STAFF REPORT

Case ZON-13-03

Applicant	OMNI Property Companies
Owner:	W&D Davis Investment Co.
Agent:	Jeff Clayton, Civil & Environmental Consultants
Township:	Blendon Township
Site:	4079 Executive Parkway (PID #110-005861 and #110-005890)
Acreage:	4.874-acres
Zoning:	Select Commercial Planned District (SCPD)
Utilities:	Central water and wastewater
Request:	Requesting to amend an existing Select Commercial Planned District (SCPD).

EXECUTIVE PARKWAY
 PARKING LOT
 DEVELOPMENT PLAN
 FRANKLIN COUNTY
 COLUMBUS, OHIO

SITE LAYOUT PLAN
 DATE: 07/23/2013
 DRAWN BY: JAC
 PROJECT NO.: 131397
 CHECKED BY: JAC
 APPROVED BY: ACH

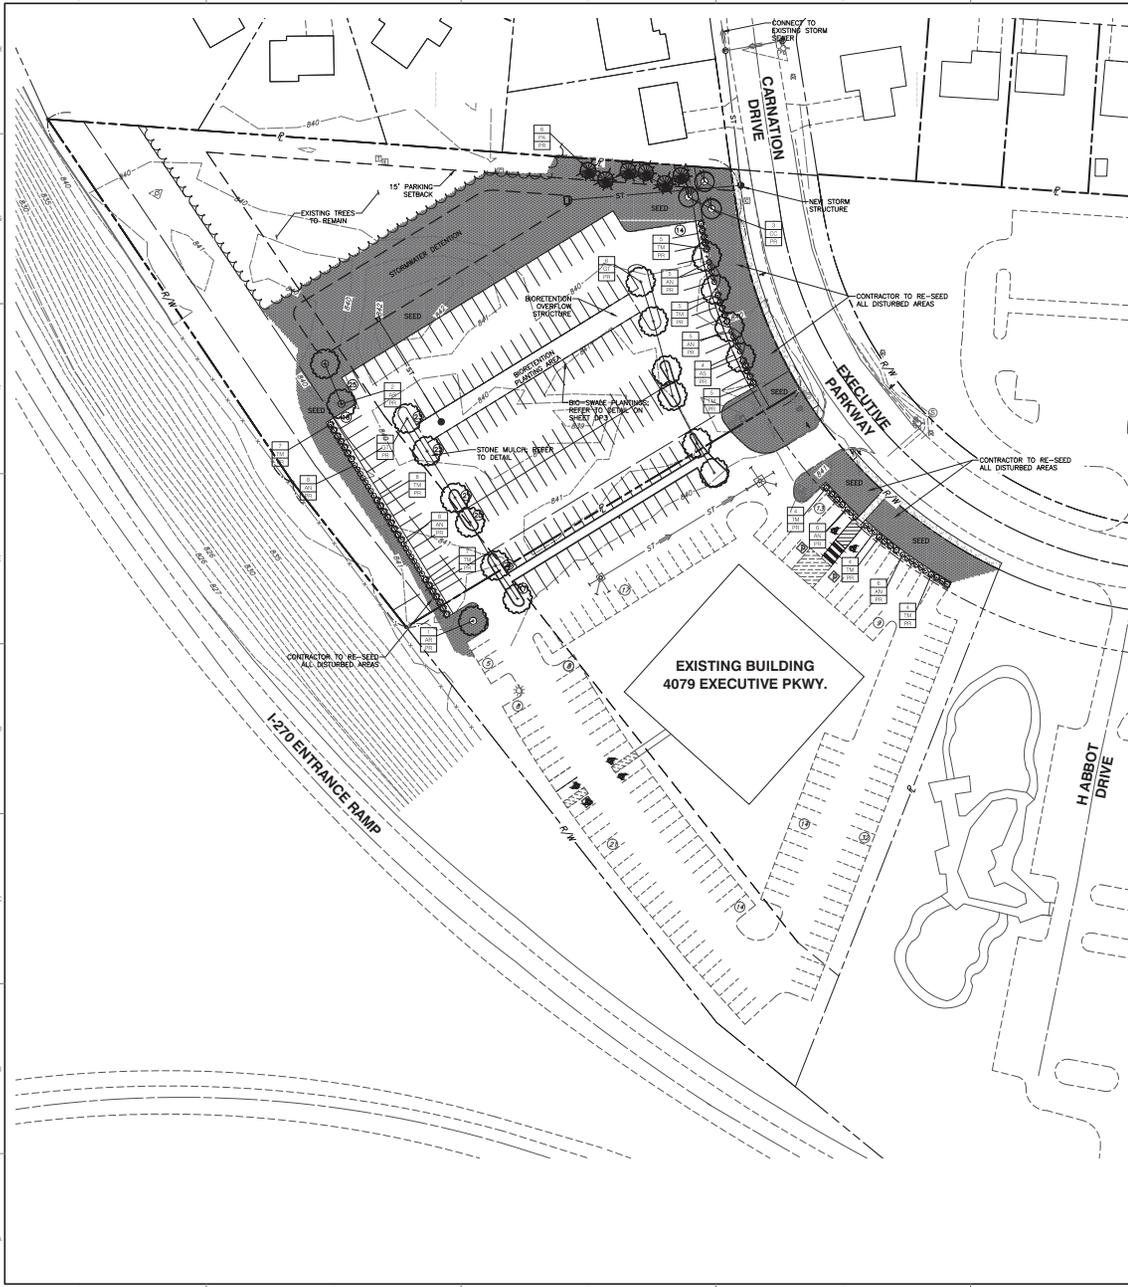
The applicant has requested a waiver from the Smart Growth Overlay (SGO) maximum number of parking spaces. The SGO limits the number of parking spaces for office uses to one space per 300 square feet of gross floor area. Based on the 43,595 square foot building, the maximum parking allowed is 146 spaces. The applicant is proposing to provide 326 spaces. The Franklin County Engineer supports this request due to regular overflow problems along Executive Parkway as a result of insufficient parking.

The applicant has requested a waiver from the General Development Standard for parking stall dimensions of 9'x18.' The applicant proposes to provide parking stalls with dimensions of 8'x16' in order to lessen the impact of providing parking in excess of the maximum required. The Franklin County Engineer's Office supports this request due to the need for additional parking in this area.

As required by the Smart Growth Overlay, a sidewalk is proposed along Executive Parkway, extending the breadth of both of the subject parcels. The proposed sidewalk is 5 feet in width and is intended to connect with the adjacent sidewalks to the north. However, the site plan shows the adjacent sidewalk terminating prior to the dividing property line. A pedestrian walkway is also proposed to connect the sidewalk to the primary entrance of the building at 4079 Executive Parkway.

1. The applicant must apply for and receive an approved Certificate of Zoning Compliance from the Franklin County Economic Development and Planning Department prior to commencing any clearing or construction activities.
2. The applicant shall not clear any trees or vegetation on the site between May 15 and August 15 to prevent potential disturbance of roosting Indiana bats.
3. The applicant must execute a cross-access easement prior to Certificate of Zoning Compliance approval.
4. In keeping with the Blendon Community Plan, the applicant must place a conservation easement on the wooded area remaining undeveloped, protecting it from any future development in perpetuity.
5. The proposed sidewalk must connect to the existing adjacent sidewalk to the north.

SITE LANDSCAPE PLAN AND DETAILS
DATE: 07/23/2013
DRAWN BY: BDF
PROJECT NO: 131397
CHECKED BY: 1-447
APPROVED BY: ACH

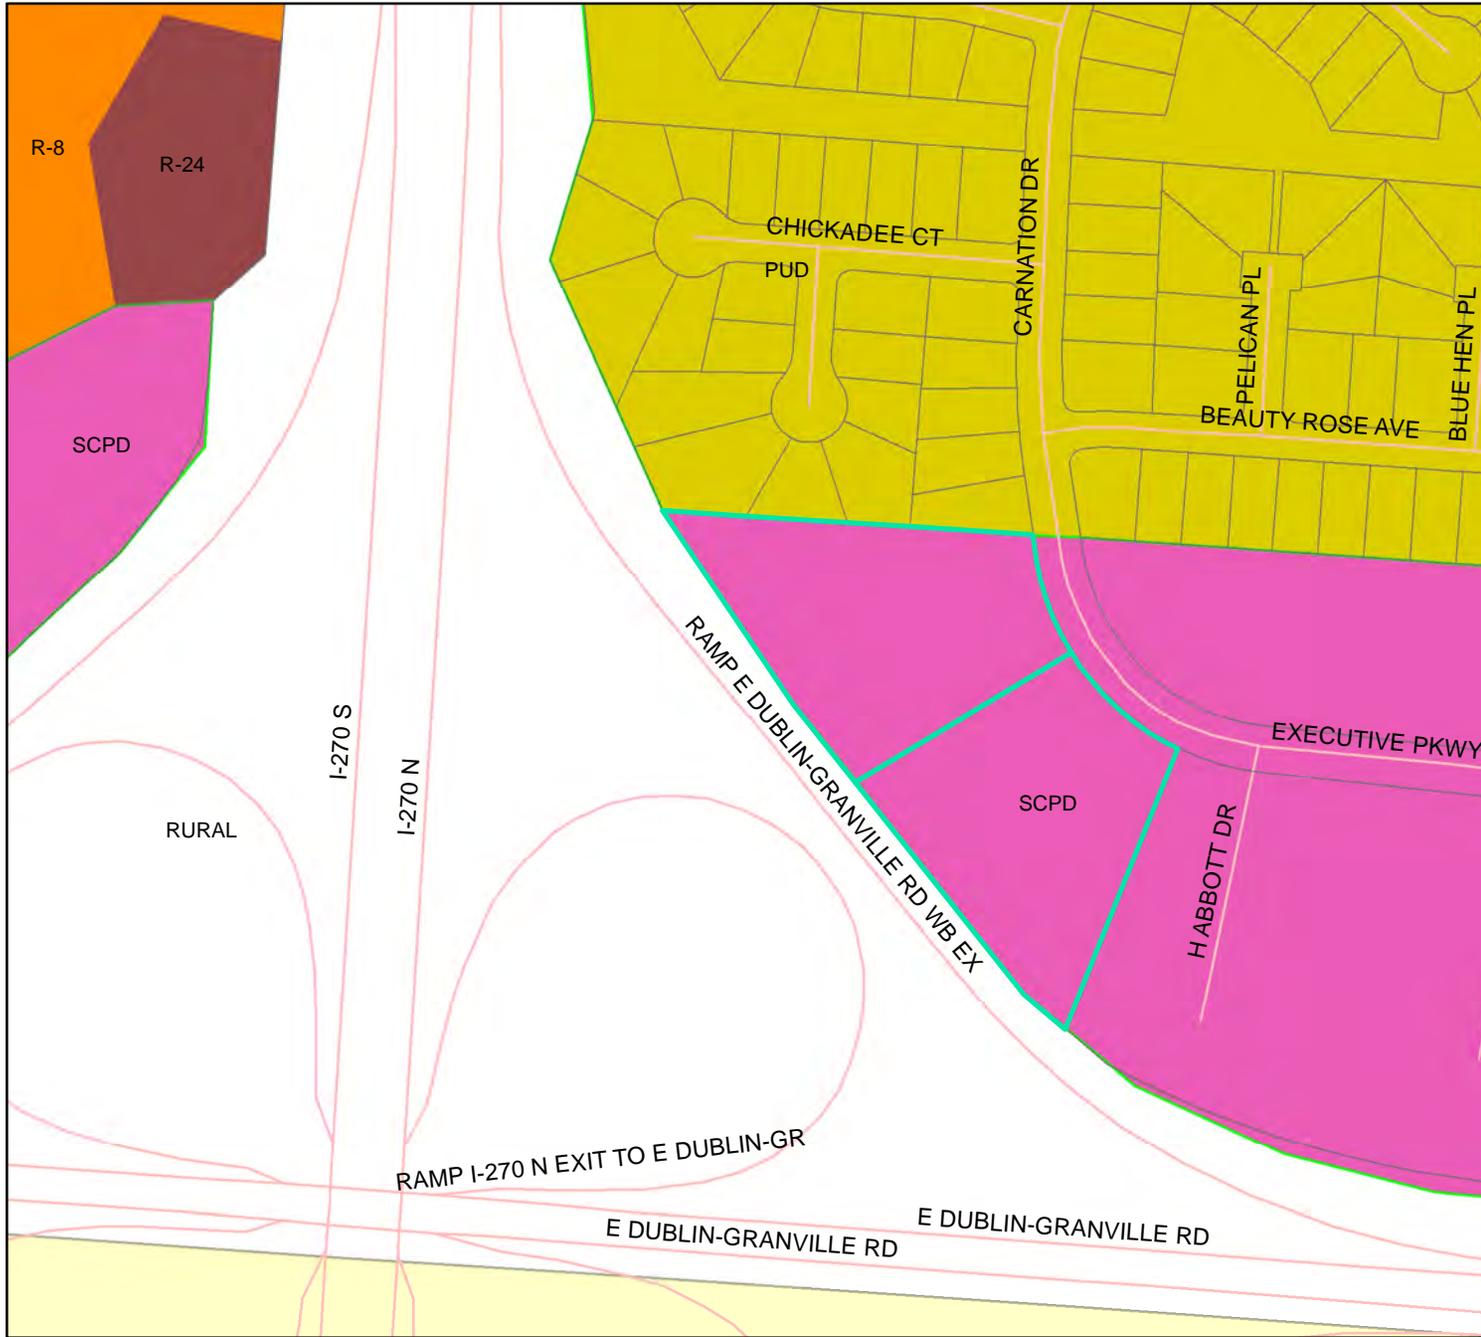
The applicant has requested a waiver from the SGO parking lot landscaping standard. Although the plan does not provide the required number of islands, it does provide the required number of trees and provides a greater area of landscaping than required by the Smart Growth Overlay. The proposed plan provides eight islands or peninsulas equal to approximately 4,000 square feet of landscaping and 19 trees.

We do not feel that the proposed 19 landscaping trees will in any way provide a comparable screen to the existing forest.

The petitioner requests a waiver for the number of islands required in the parking lot.
